# PORTLAND WATER DISTRICT

ADDENDUM NO. 1
TO
CONTRACT DOCUMENTS
FOR

Hermit Thrush Road & Glenden Road - Water Main Replacement
Cape Elizabeth, Maine
February 8, 2023

1 OF 3

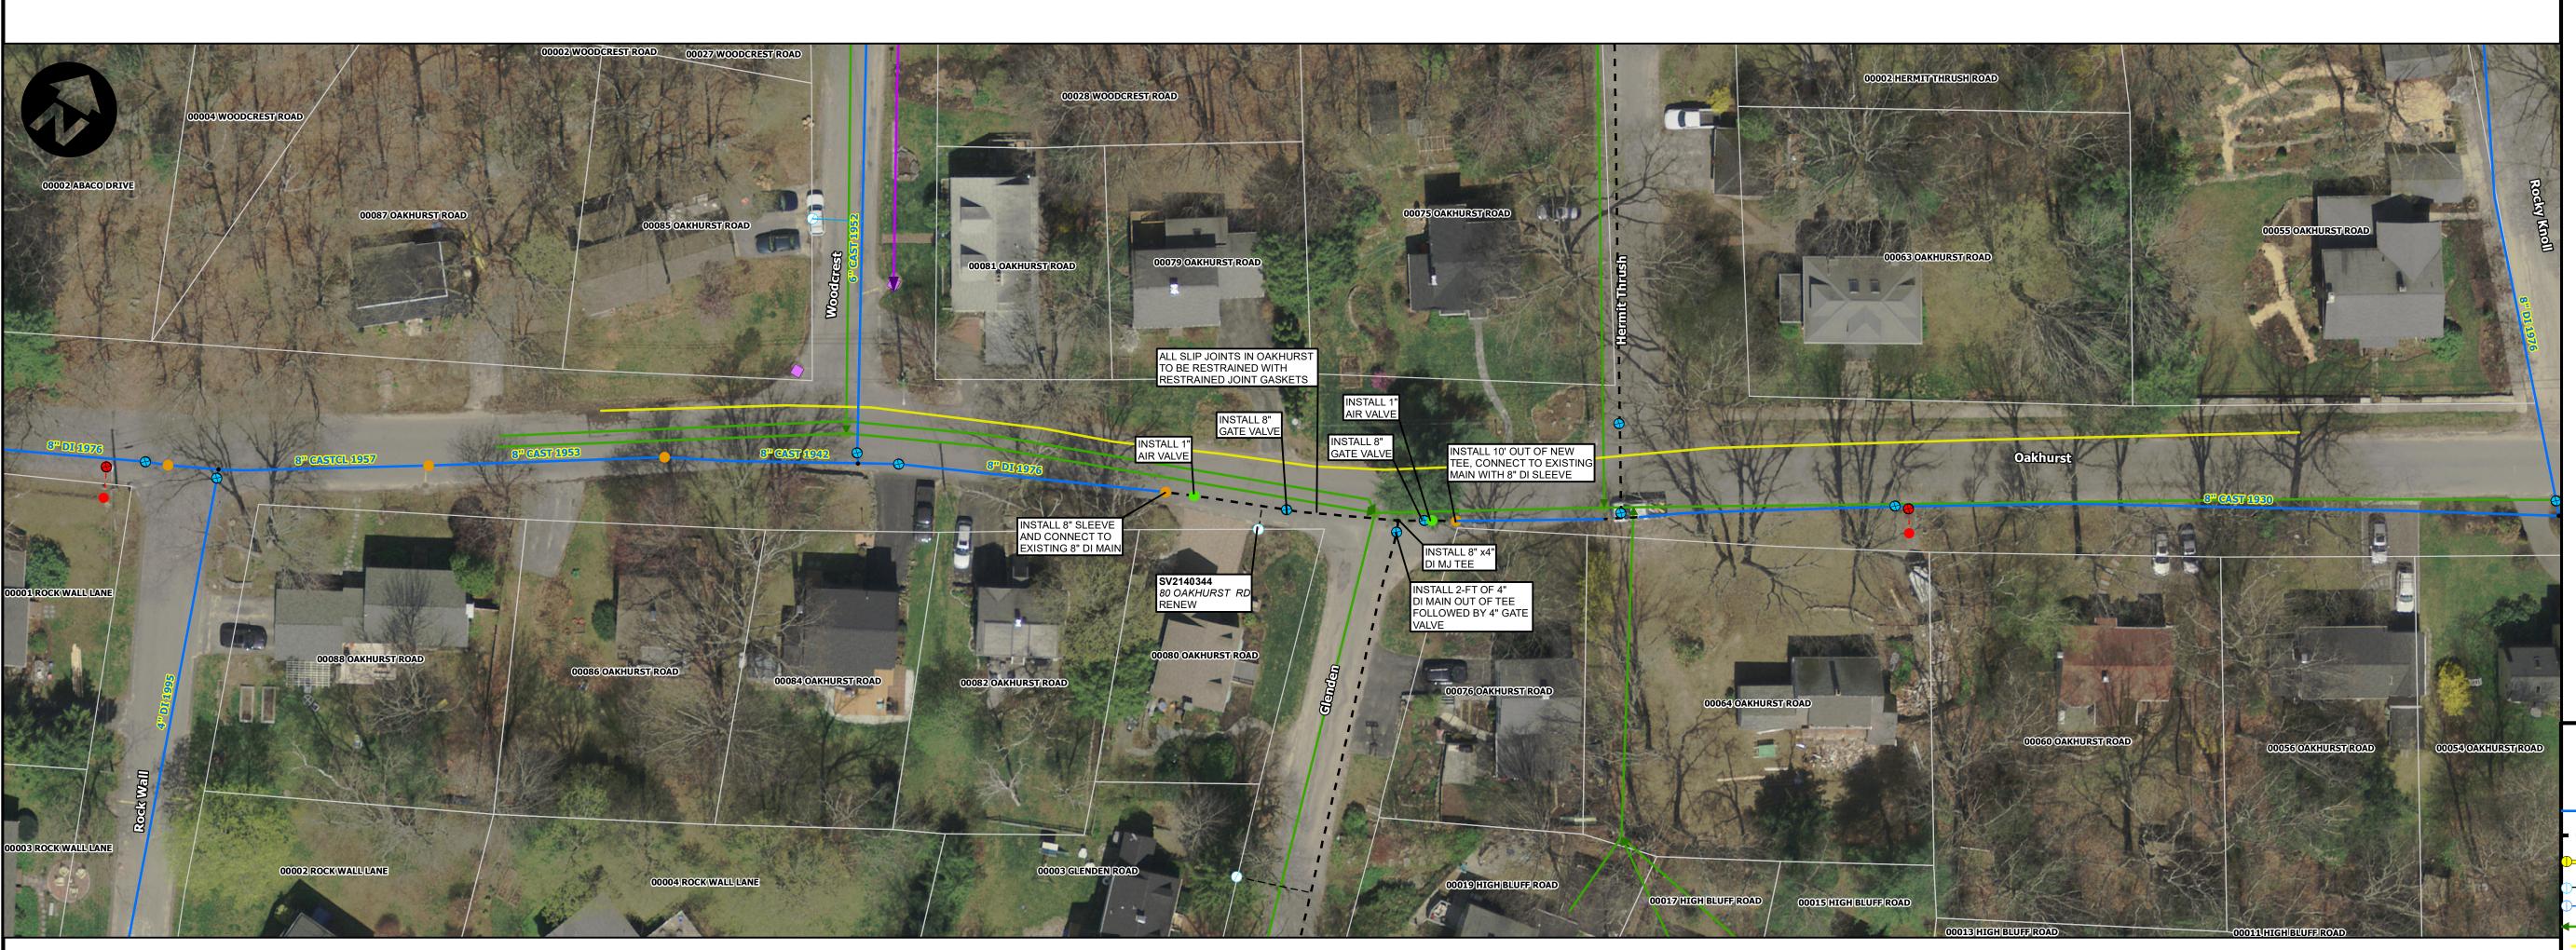
- 1. Sheet 1 of 3. Sheet updated to reflect changes to plan at connection of Hermit Thrush Road and Oakhurst Road.
- 2. **Sheet 3 of 3**. Sheet updated to reflect changes to plan at connections of Hermit Thrush Road and Oakhurst Road and Hermit Thrush Road and Arrow Point Road.
